**DC-9****SERVICE BULLETIN****REVISION TRANSMITTAL SHEET**

BULLETIN 24-76

ELECTRICAL POWER - General - Revise Routing and Clamping for Lavatory Pump-to-Timer Wire Assembly.

Revision 1 August 16/85

REROUTE AND RECLAMP LAVATORY PUMP WIRES

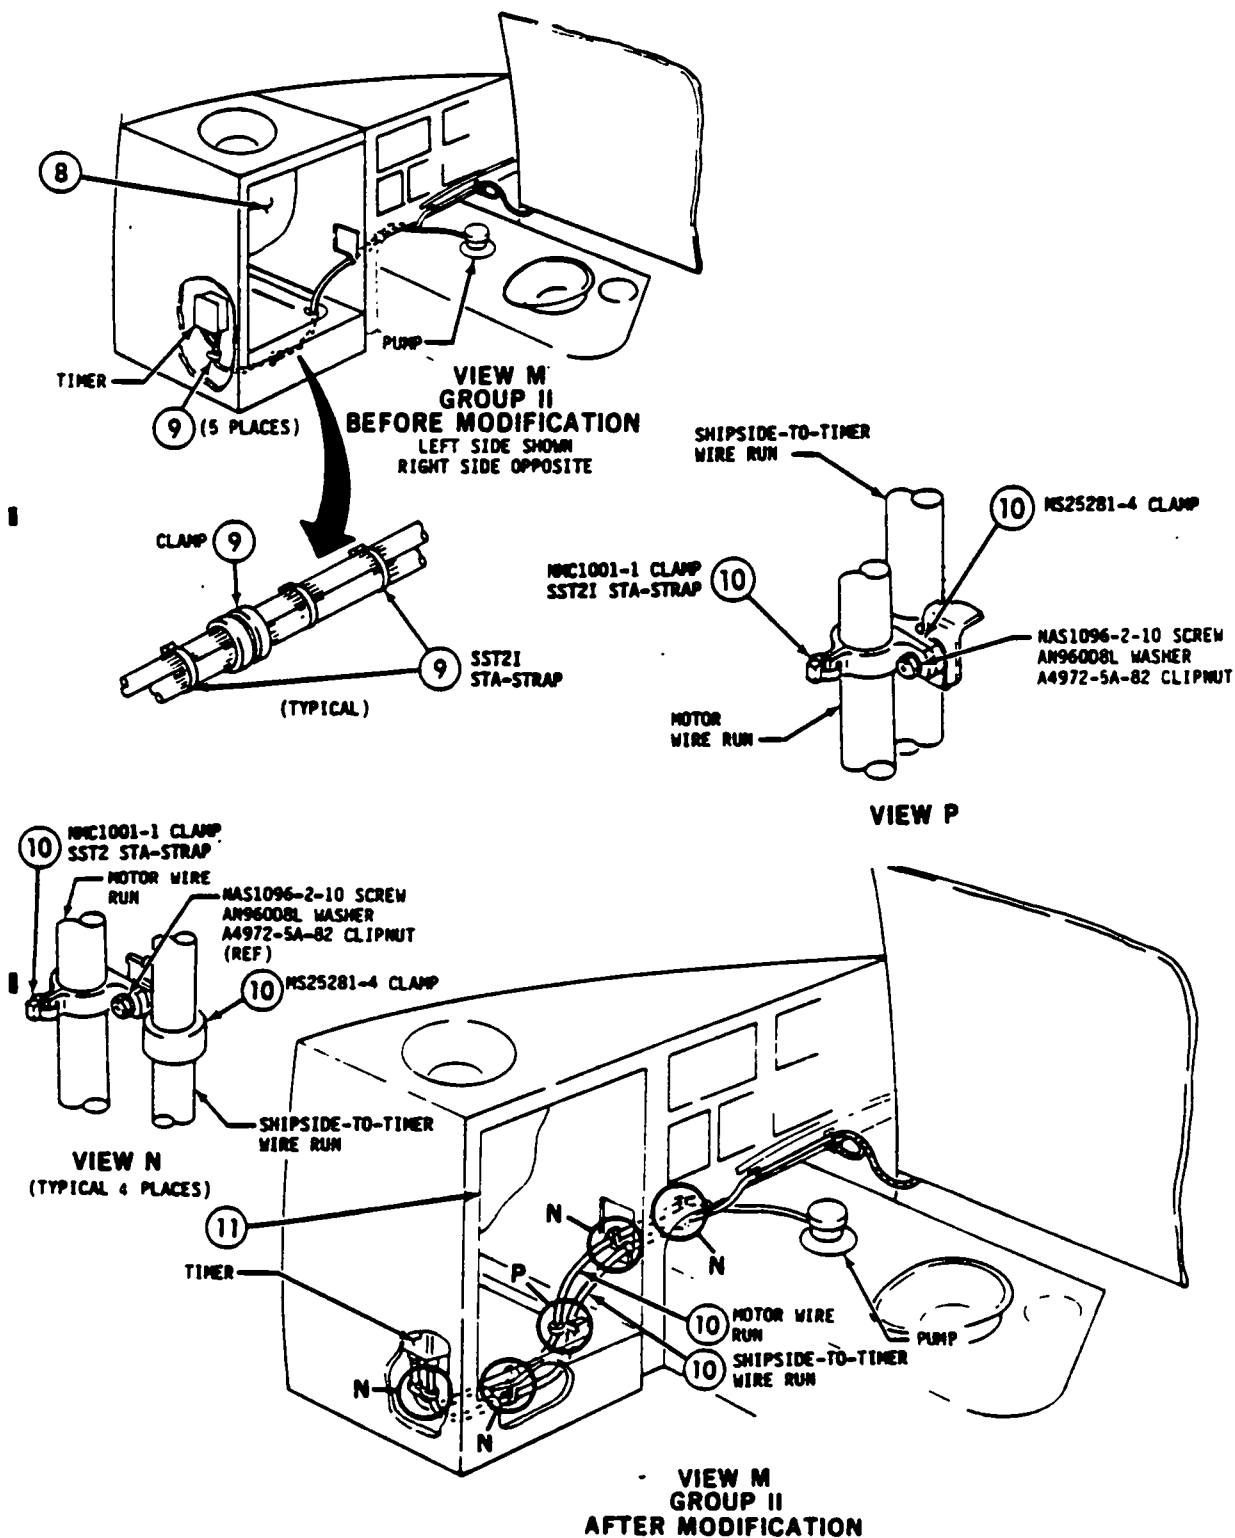
Pages 13, 14, 16, thru 19, 21, 22: Added Note to Figure 1, steps 6 and 10, and Figure 2, Step 3.
Change part number and illustration of clamp on the shipside-to-timer wire run to MS25281-4, was NMC1001-1.

- ① OPEN WASHSTAND DOOR.
- ② INSTALL ASMS-A SWIVEL MOUNTS USING 501 ADHESIVE WITH 501A ACCELERATOR.
- ③ REMOVE EXISTING SST2I STA-STRAPS AND CLAMPS FROM WIRE BUNDLE TO SEPARATE LAVATORY PUMP-TO-TIMER WIRE ASSEMBLY FROM OTHER WIRES.
- ④ RELOCATE SEPARATED WIRE RUNS AS SHOWN.

- ⑤ INSTALL PERMACEL P-421 TEFLON TAPE ON WIRING EXTENDING INTO CONDUIT.
- ⑥ REVISE CLAMPING AS SHOWN USING NEW AND EXISTING ATTACHING PARTS.

- ⑧ OPEN WASHSTAND DOOR.
- ⑨ REMOVE EXISTING SST2I STA-STRAPS AND CLAMPS FROM WIRE BUNDLE TO SEPARATE LAVATORY PUMP-TO-TIMER WIRE ASSEMBLY FROM OTHER WIRES.
- ⑩ REVISE CLAMPING AS SHOWN USING NEW AND EXISTING ATTACHING PARTS.

NOTE: IT IS PERMISSIBLE TO USE LARGER OR SMALLER CLAMPS TO ENSURE A PROPER FIT.

NOTE: IT IS PERMISSIBLE TO USE LARGER OR SMALLER CLAMPS TO ENSURE A PROPER FIT.

FIGURE 2 (SHEET 2 OF 4)

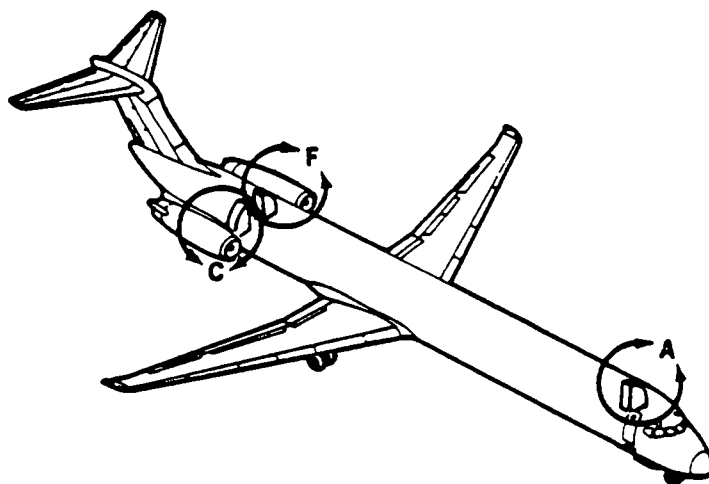
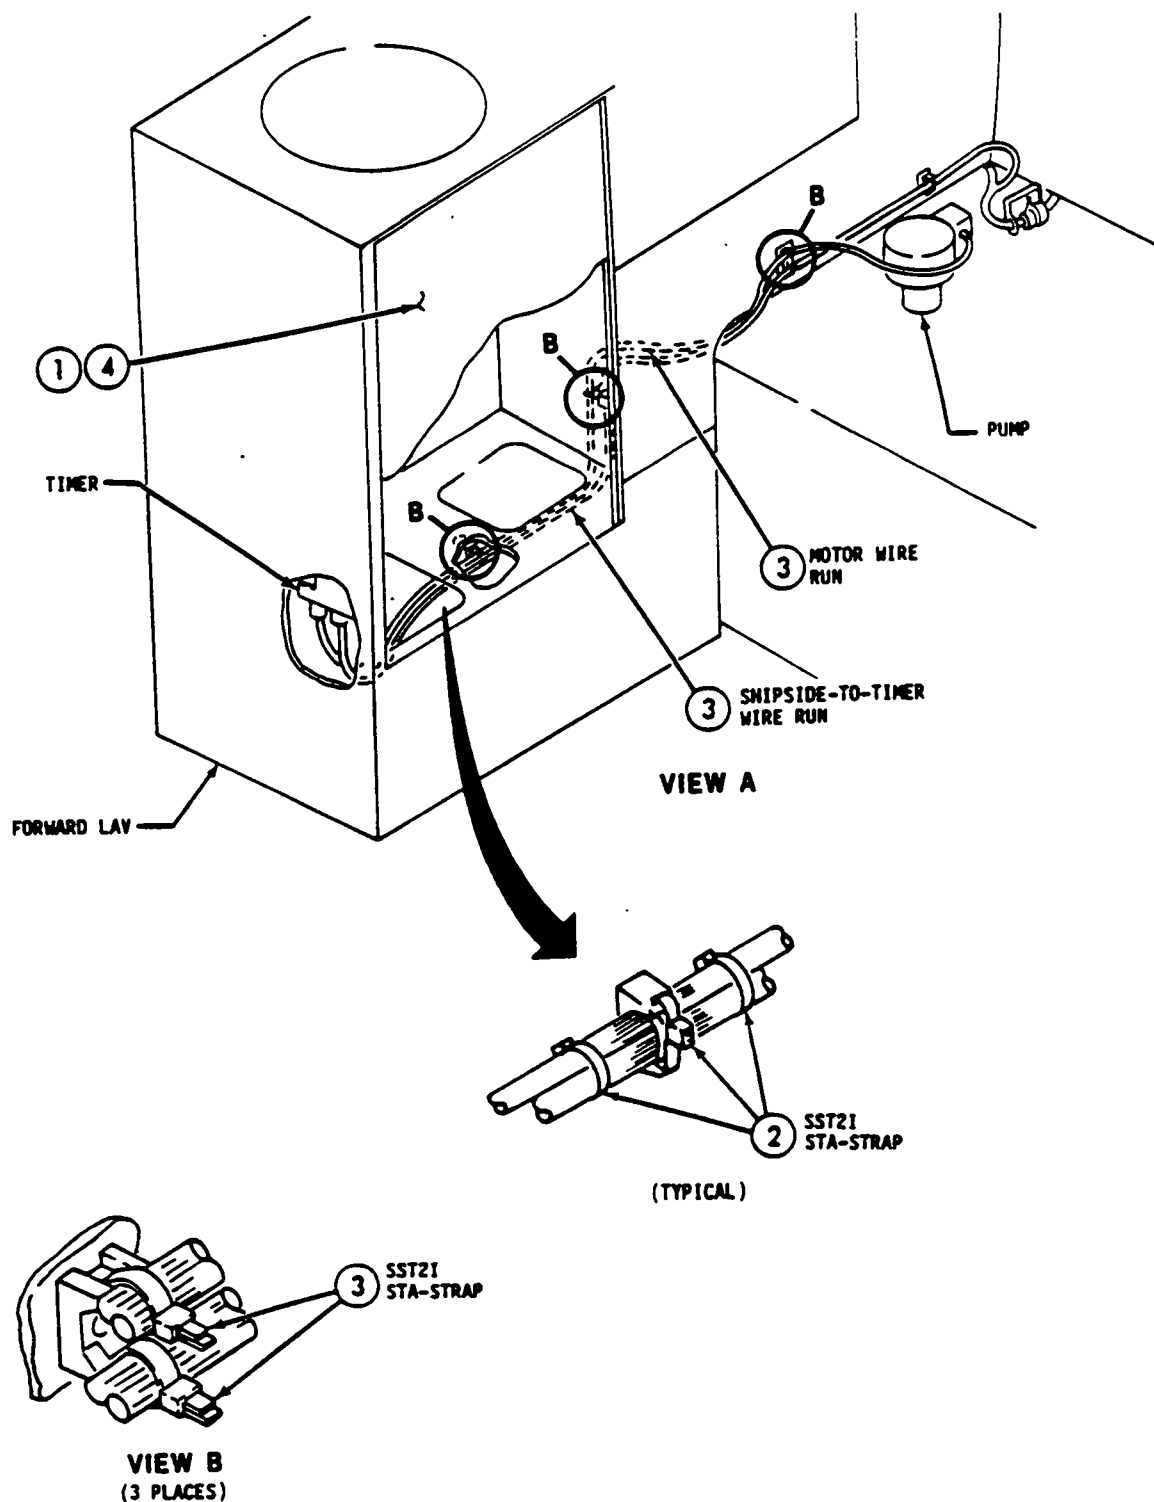
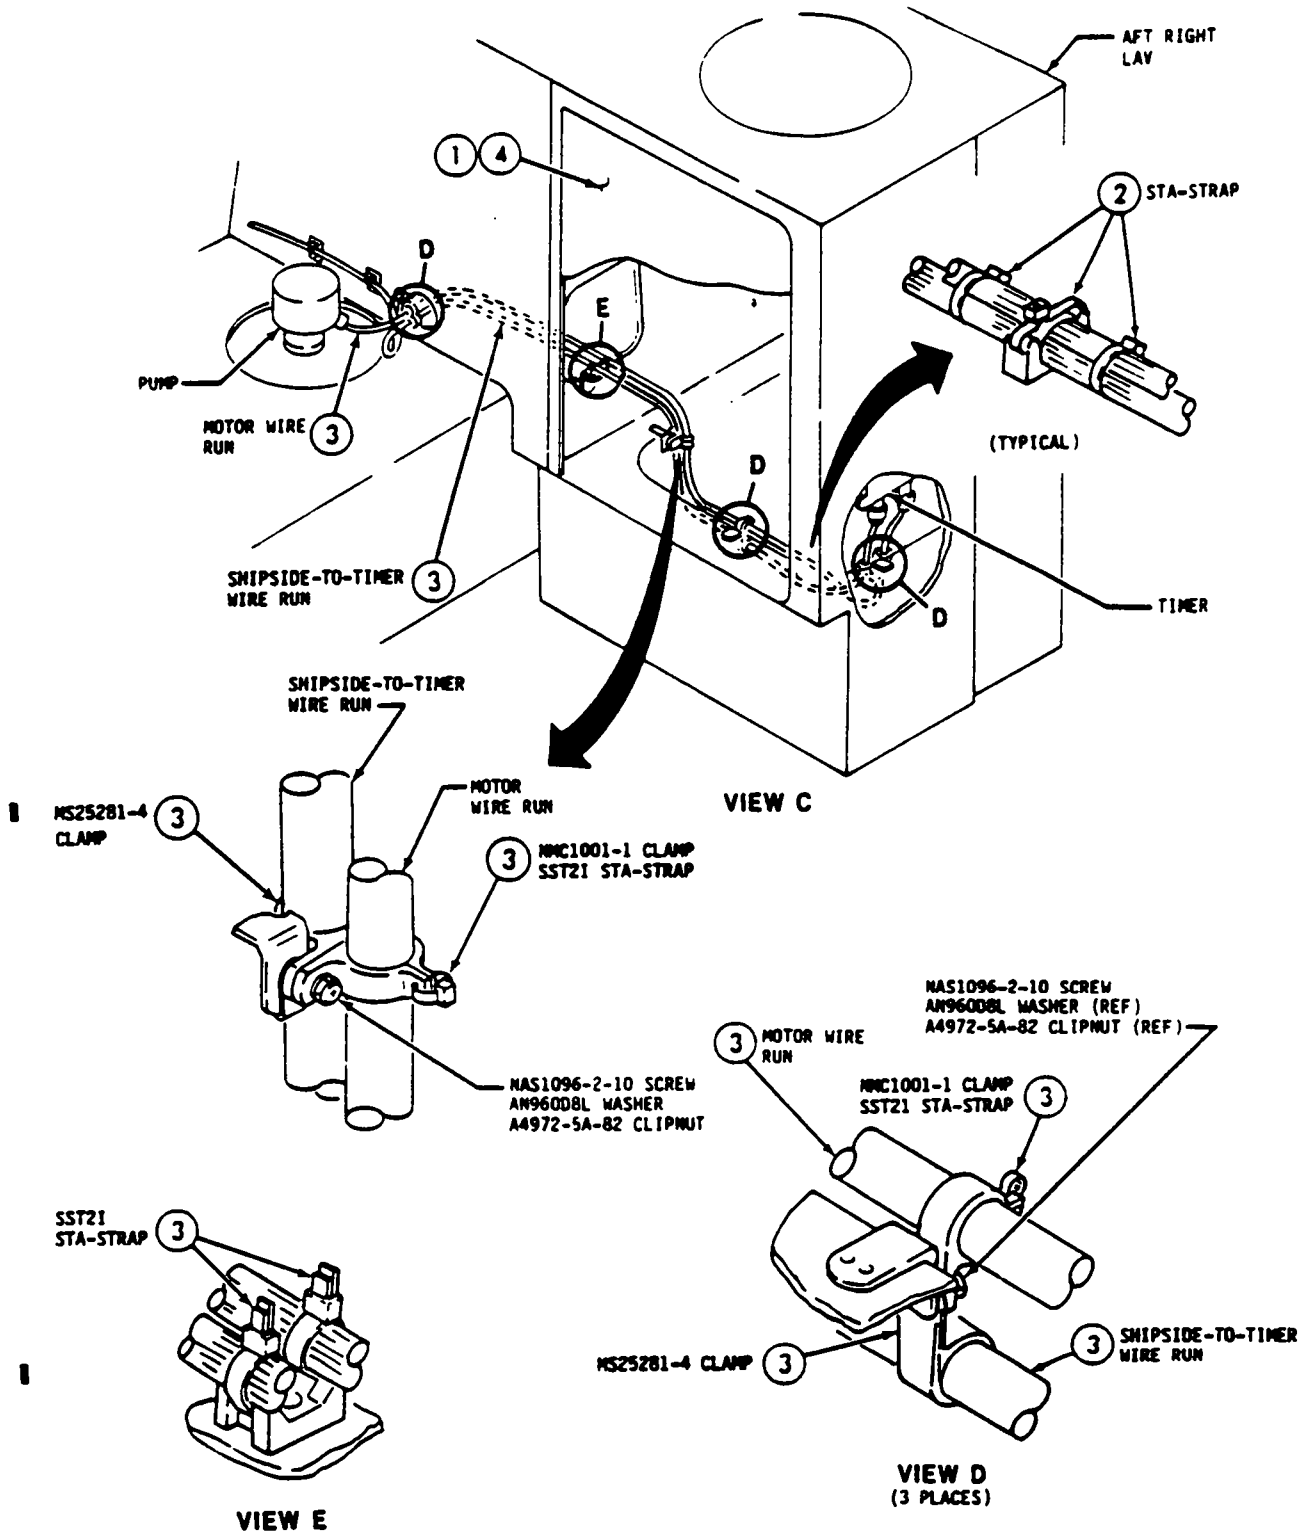
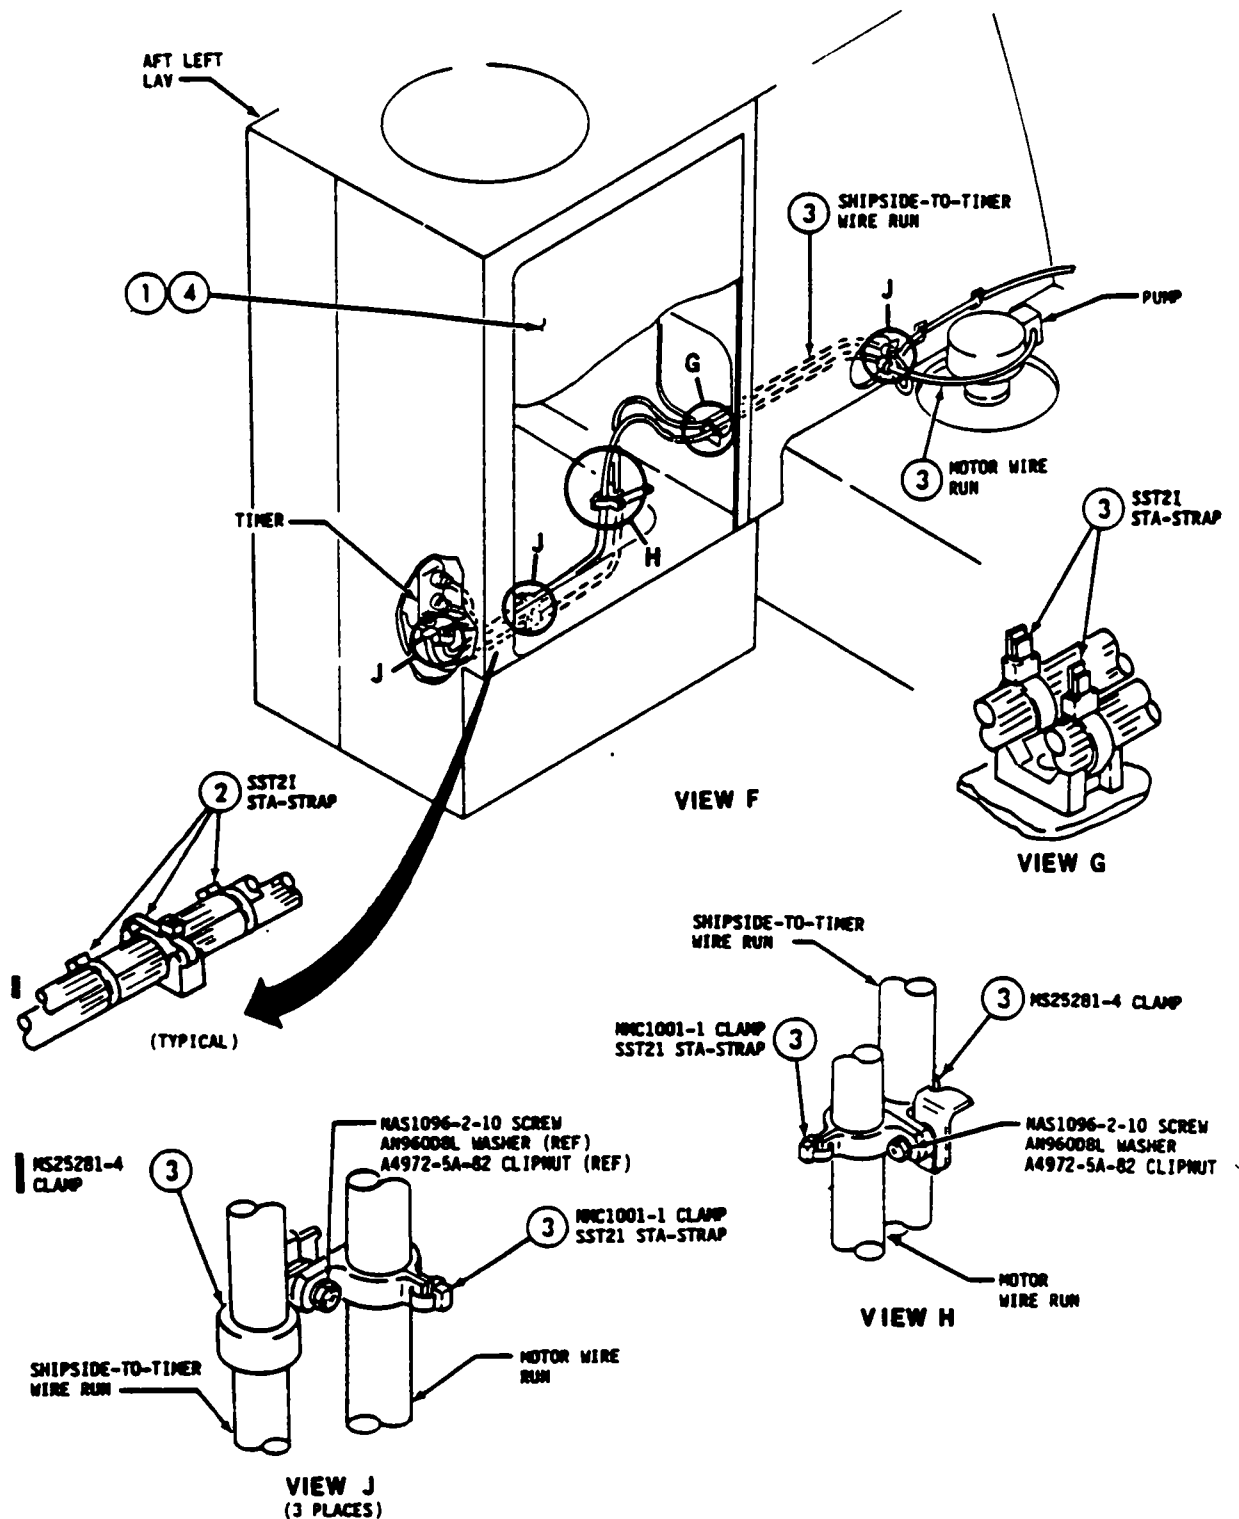
- ① OPEN WASHSTAND DOOR.
- ② REMOVE EXISTING SST21 STA-STRAPS FROM WIRE BUNDLE TO SEPARATE LAVATORY PUMP-TO-TIMER WIRE ASSEMBLY FROM OTHER WIRES.
- ③ REVISE WIRE RUN CLAMPING USING NEW AND EXISTING ATTACHING PARTS.

IT IS PERMISSIBLE TO USE LARGER OR SMALLER CLAMPS TO ENSURE A PROPER FIT.
